Bangla Poshak Ltd.

Sikder Complex, Chaidana, National University, Gazipur, Bangladesh
(23.961573, 90.380068)

29 March 2014

Observations

**Tested column at
ground level- Brick
aggregate observed.**

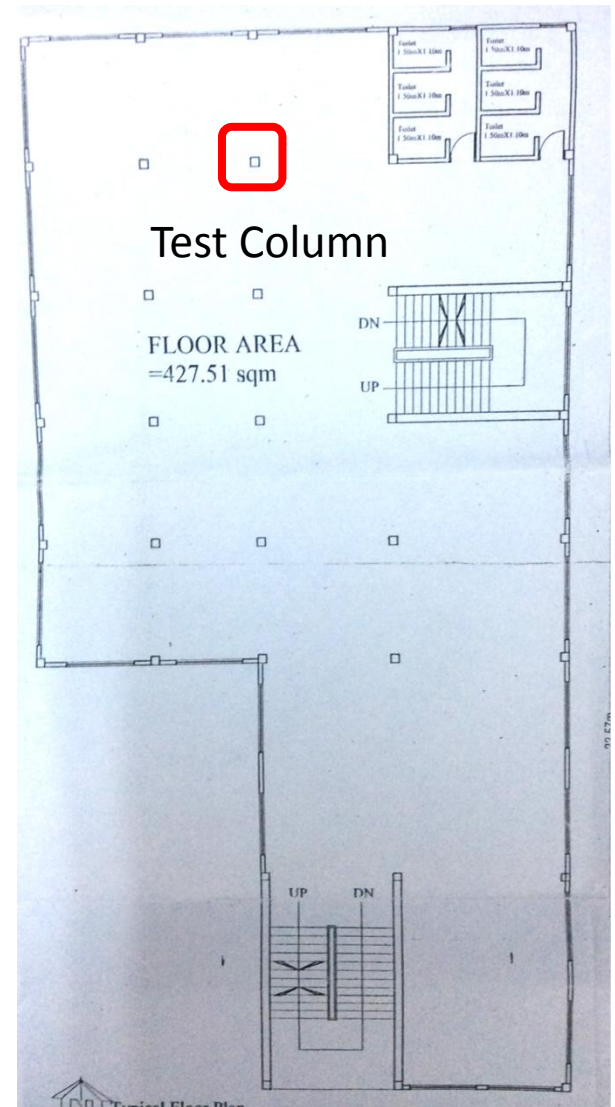
**Preliminary calculations indicate that the working
stresses in some columns are at a high level.**

**Building Engineer to check that columns have been
designed to accommodate applied loads including
edge cantilevers and areas of heavy loading.**

Typical Column Layout

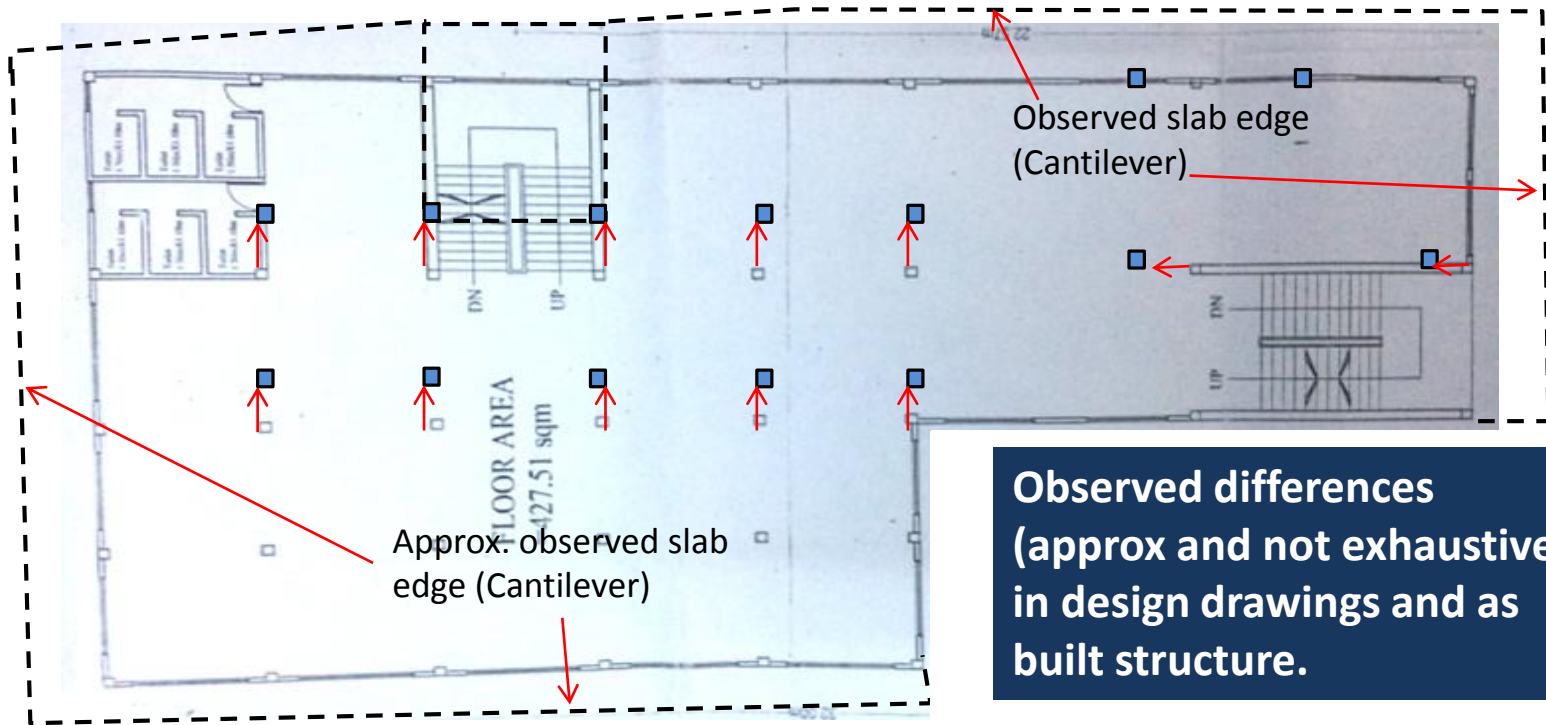
Design drawings are not consistent with the as-built structure

Differences in column locations and sizes, edge cantilevers, core locations and reinforcement arrangement observed.

Accurate set of as-built documentation required

Typical Edge cantilever supporting brick facade.

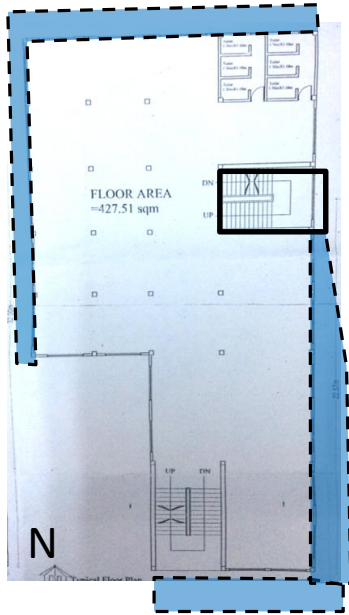
Undocumented cantilever slabs and stair observed beyond column lines in a number of locations at all levels of the building.

Brick masonry facade weight supported at the tip of cantilevers.

West stair cantilever.

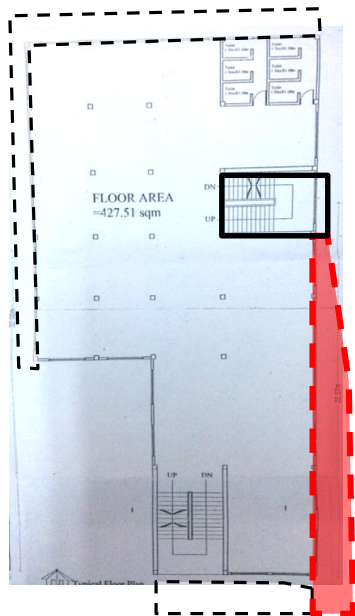
On west facade it is unclear at ground level whether the edge is a cantilever or whether supported off an additional line of columns. Design review required.

**Typical floor build up in
toilet areas and
additional step up in
cubicle.**

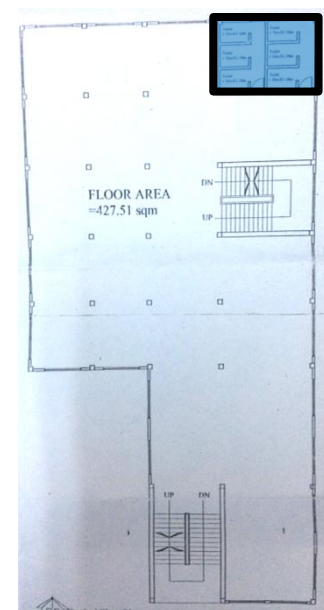
**Increased floor build-up in toilet block areas
(~300mm general to ~450mm in cubicles).**

**Partition walls around block and between
additional cubicles**

Water Tank Locations

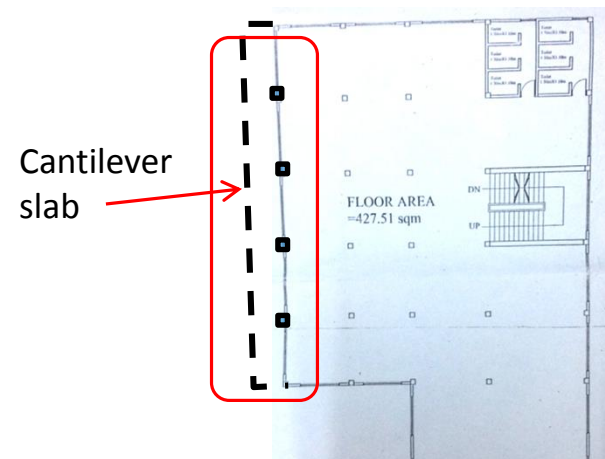
Water tank storage at roof level
